Appendix 7 Landscape and Visual

- 7.3.1 The applicant has set out their assessment of the likely effects of the A122 Lower Thames Crossing project on the landscape resource and on visual receptors during construction and operation.

Green Bridge cross sections

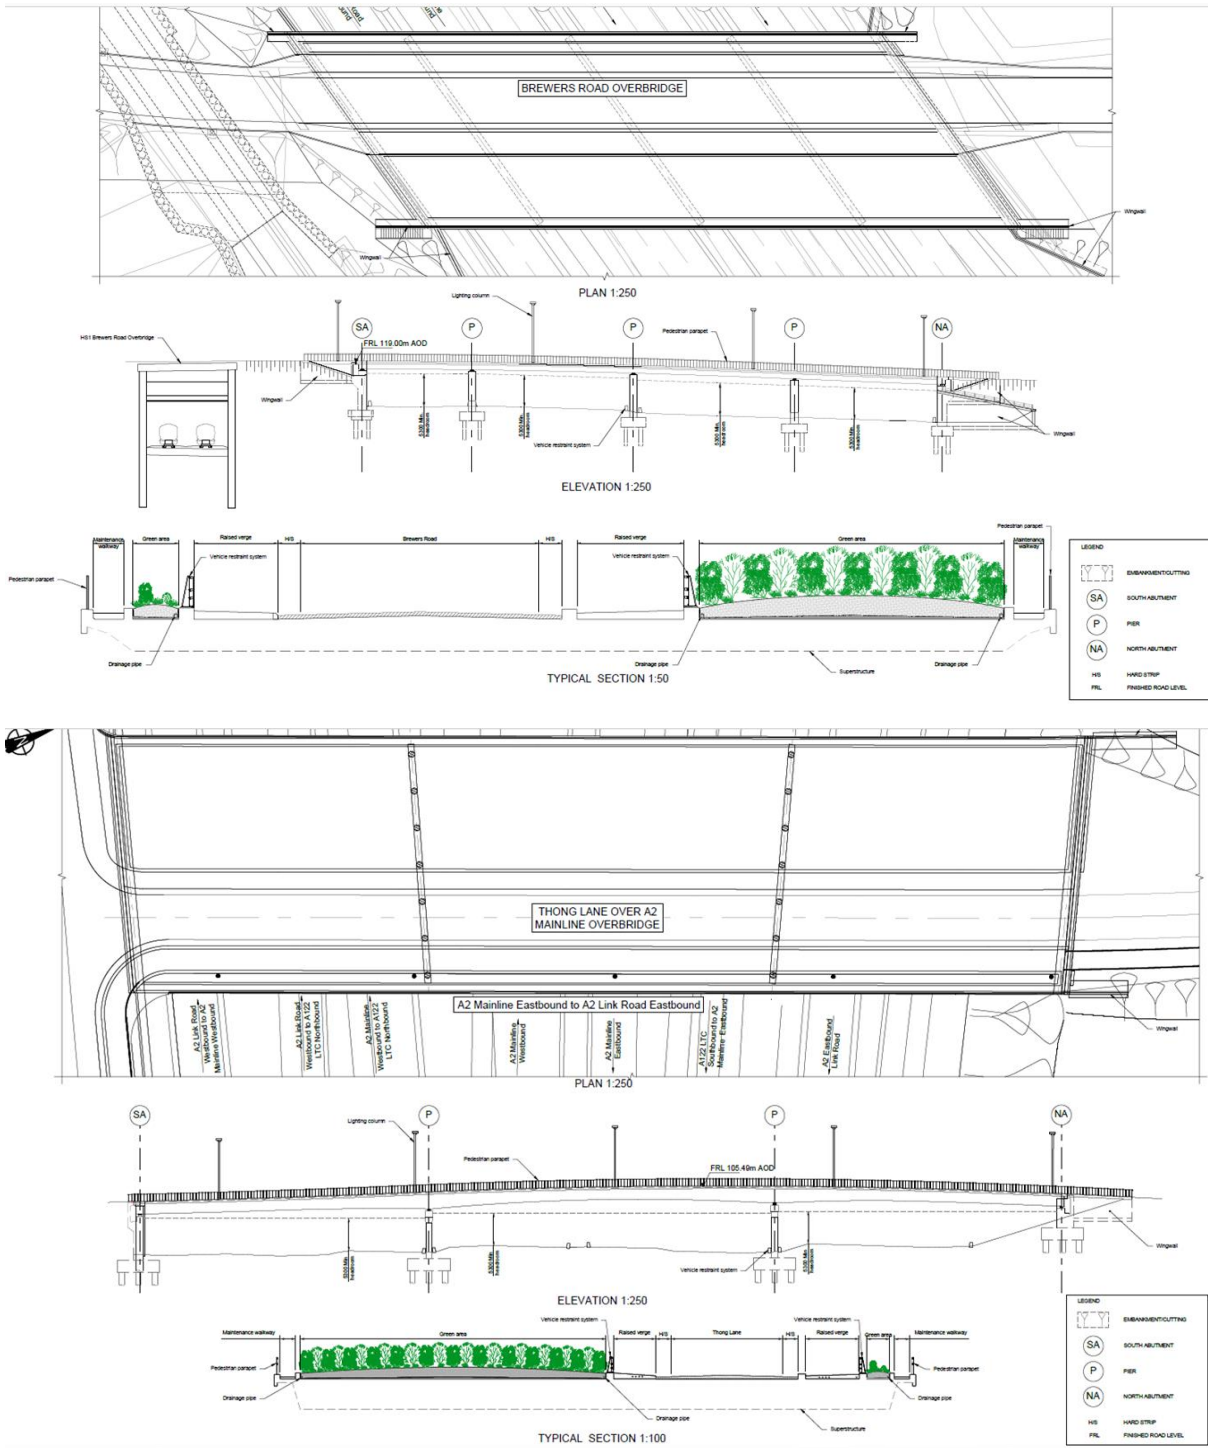
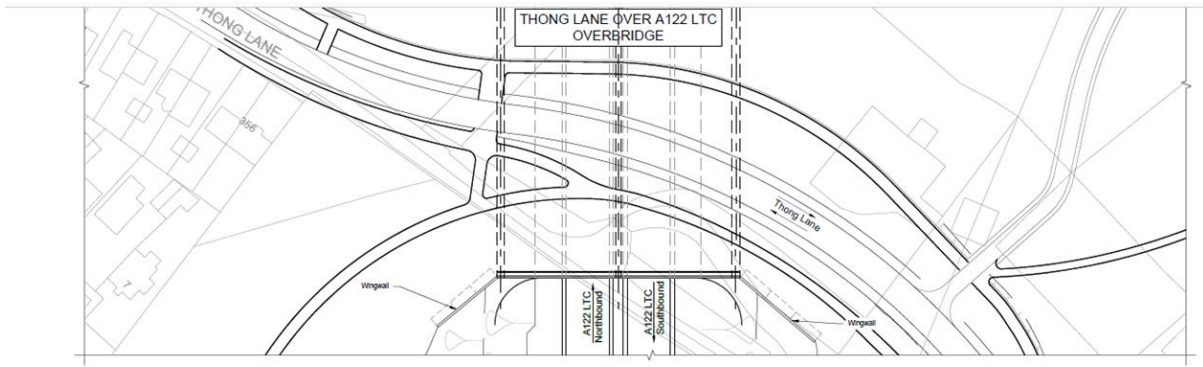
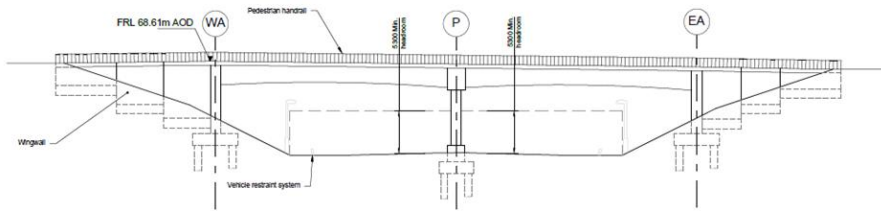
- (iii) Doc 2.13 Volume B (sheets 12 to 79) at Sheet 20 provides a plan of the bridge structure. It is shown without dimensions, but it is clear that there will be a very narrow strip of vegetation on one side, and a wider strip to the other – presumed east – side (see extract at Appendix 1)

- (i) The proposals provide a drawing of the proposed bridge in Document 2.13 Volume B (sheets 12 to 79) at sheet 21 (see extract at Appendix 1). The drawing does not provide any dimensions, but – similar to the Brewers Road bridge – there is significant width of planting on only one side of the bridge. This bridge crosses multiple lanes of traffic, and is surrounded by hard surfaces, walls and other large structures. In addition, it is located close to the new junction of the A2/A122, with its multiple levels and structures. The experience for WCH users of the bridge will not be pleasant, as they will experience the noise and views of traffic and a more urbanised and open landscape.

- (i) By contrast, the design of the Thong Lane north bridge, shown in drawings in LTC document 2.13 Volume B (sheets 12 to 79) sheet 26 (see extract at Appendix 1), has two dedicated paths for WCH users, separated from the roadway and enclosed by a total of four widths of planting. The bridge users will be screened from the new A122 below, which will have far fewer lanes of traffic than the modified A2 and its linking roads.

- b. Overall, the designs for the proposed green bridges at Brewers Road and Thong Lane south will not be adequate for the bridges to function as needed. Notably, the bridges need to be broader, and provide wider tracts of vegetation on both sides of the bridge and on either side of the WCH route to ensure that recreational users are less exposed to the views and noise of the widened road. The bridges cannot compensate for the significantly increased severance, loss of landscape quality, biodiversity and visual amenity along this transport corridor. However, by providing the maximum possible width and depth, the green bridges may be able to provide functioning ecological and landscape links, as well as an improved experience for users.
